Addendum No. 3

Project Name: NECSD – New CTE Building

CSArch Project No. 108-2303

1 ENLARGED FLOOR PLAN - COSMETOLOGY
A604 1/4" = 1'-0"

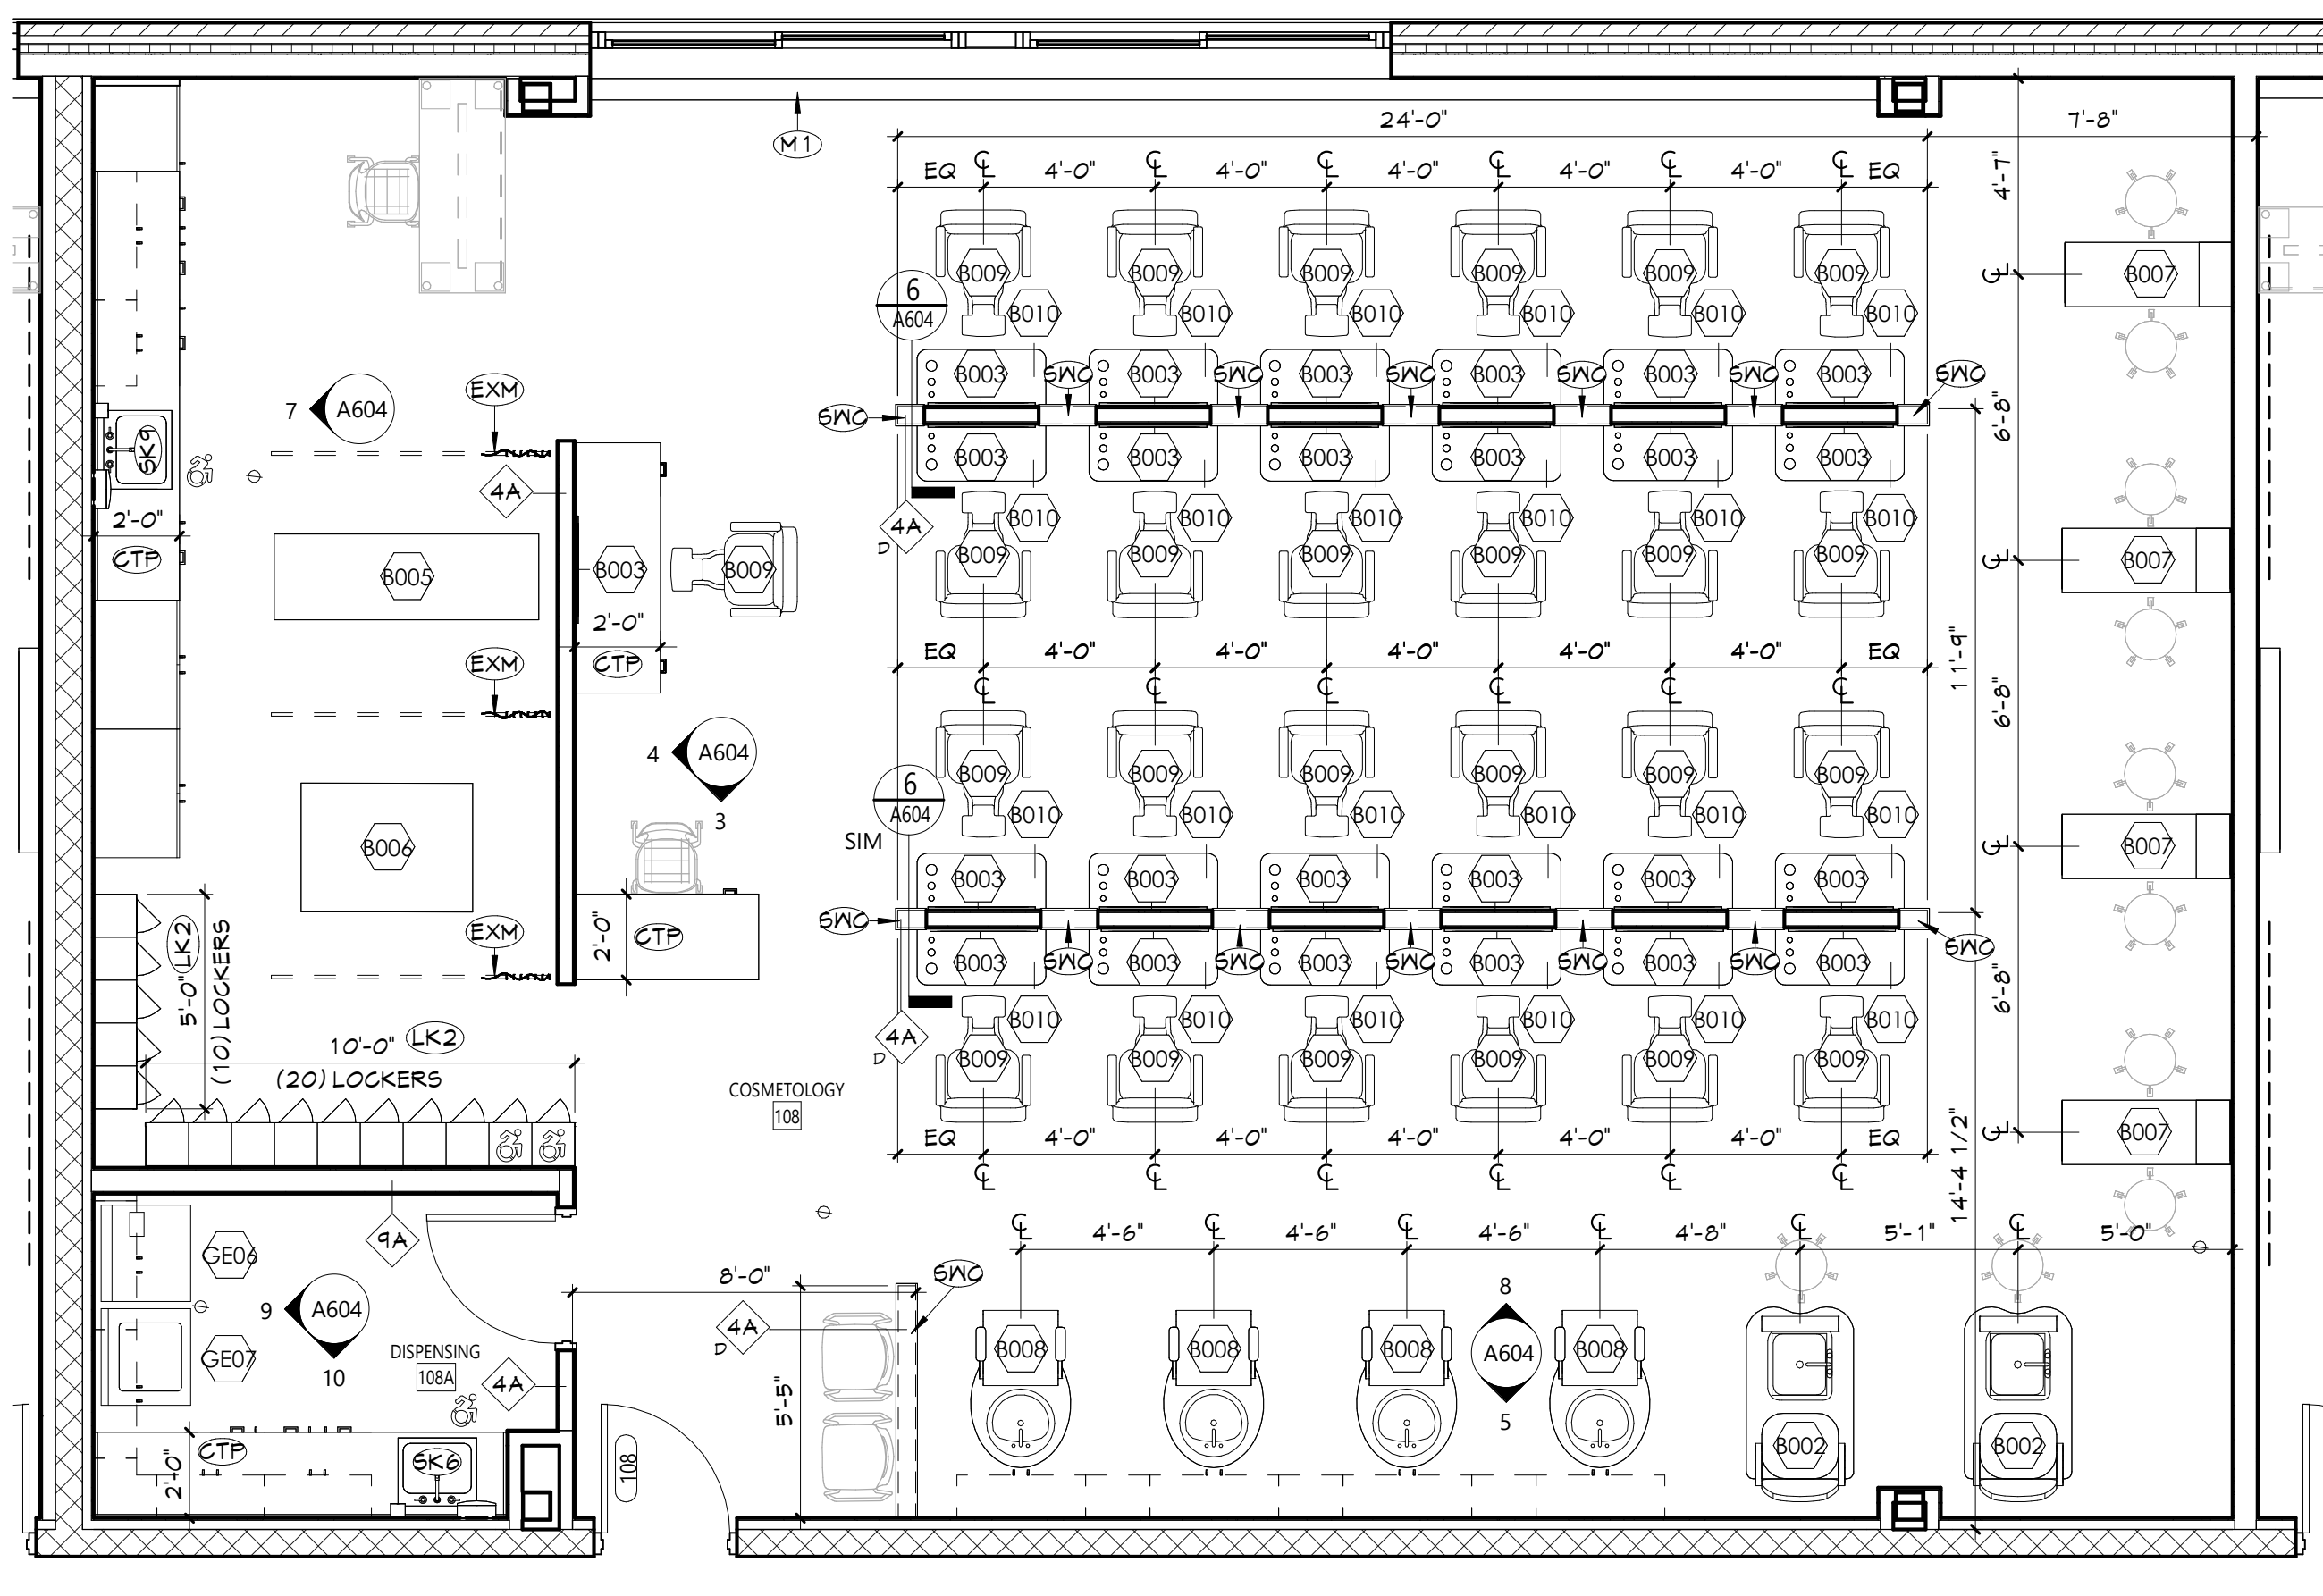
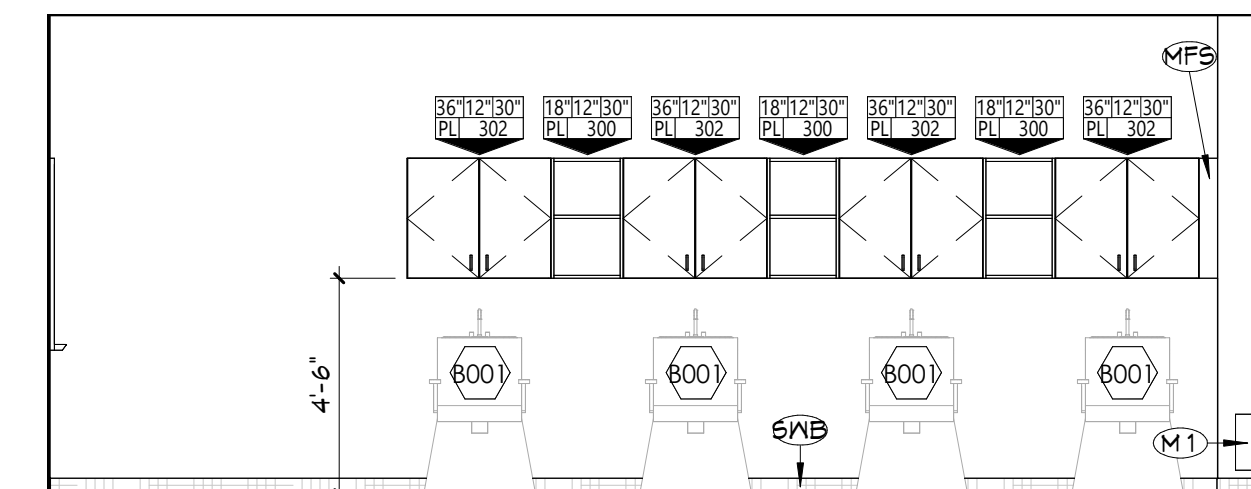
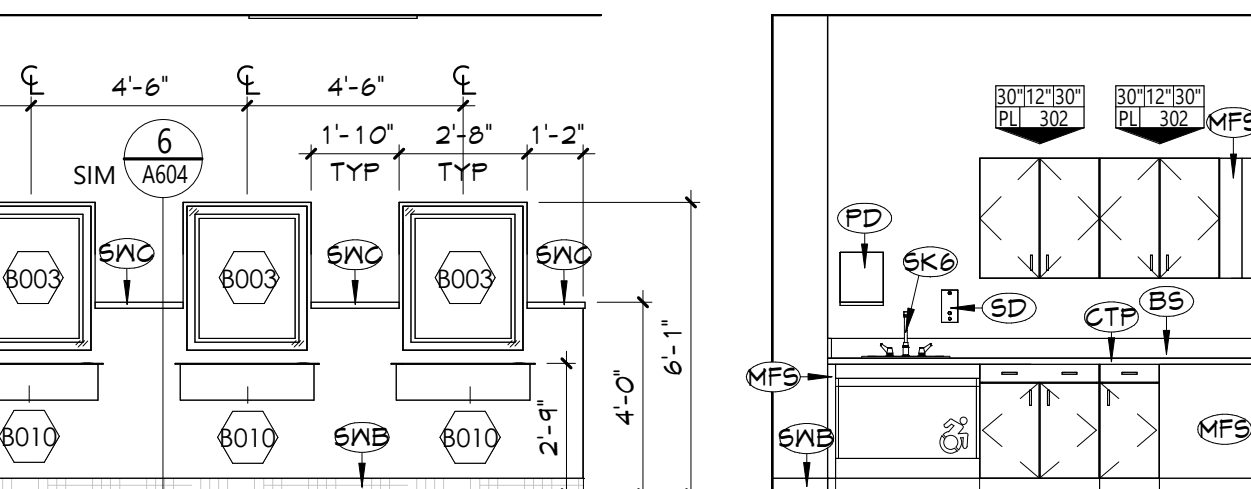
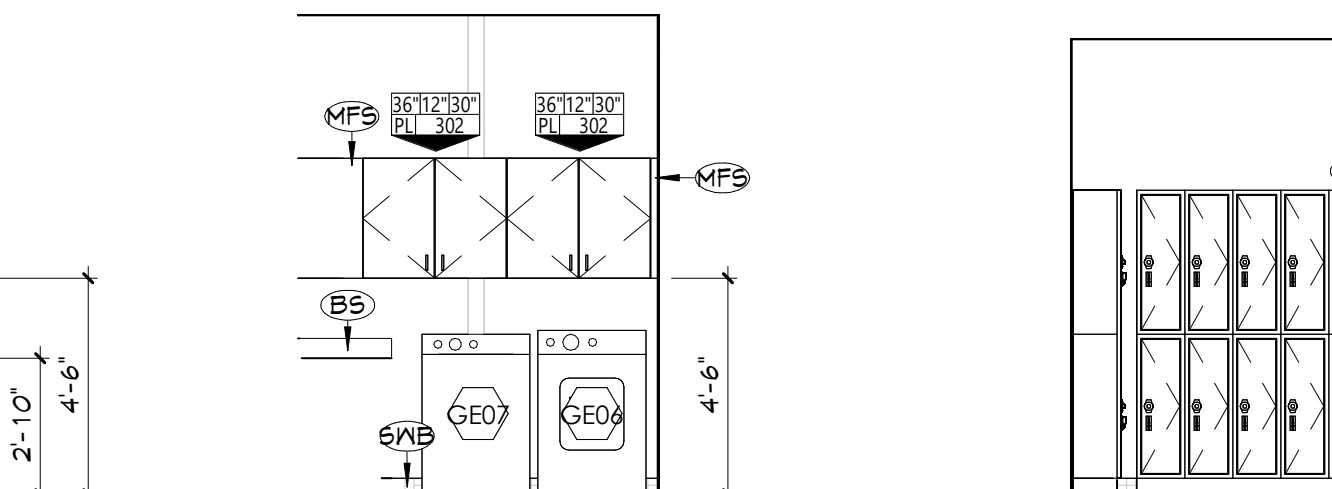
| 10 | A | Equipment List | <p>The equipment list is understood but incomplete. It is fine for equipment positioning and electrical requirements, but there is specific information missing that is required for an accurate quote. There are accessories for the brake lathe and the wheel balancers that aren't included on the plans but are typically required to be included in the price quote. For example, the wheel alignment system, described on the plan as "head unit", HE421, is incomplete. There are several configurations available for a wheel alignment system. HE421 just describes the measuring sensor type, but does not include the console which houses the PC, monitor, printer, etc. There are options for the wheel alignment lift, RX12 that might be beneficial in a student learning environment but are not indicated. Please review the contractor required equipment lists and clarify which accessories should be included in the bid.</p> | 4/30/2024 | Worth Construction Co., Inc. | <p>Provided as part of addendum #3.</p> | Yes | A604, A613, A615 | | Add #3 |
